No. 87-15

Oil Pressure Change in 1987 MCM V6 Stern Drive Engines

Figure 1. G.M. Engine Code

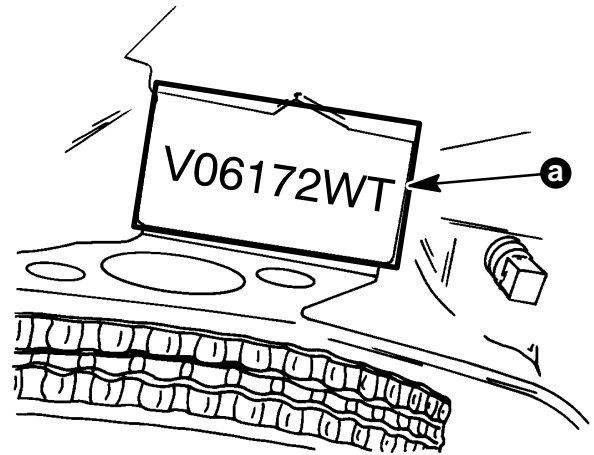
The GM engine code number is located on the front of the engine near the circulation pump. Below is an example of reading the date code. Figure 1

a - Engine Code Location
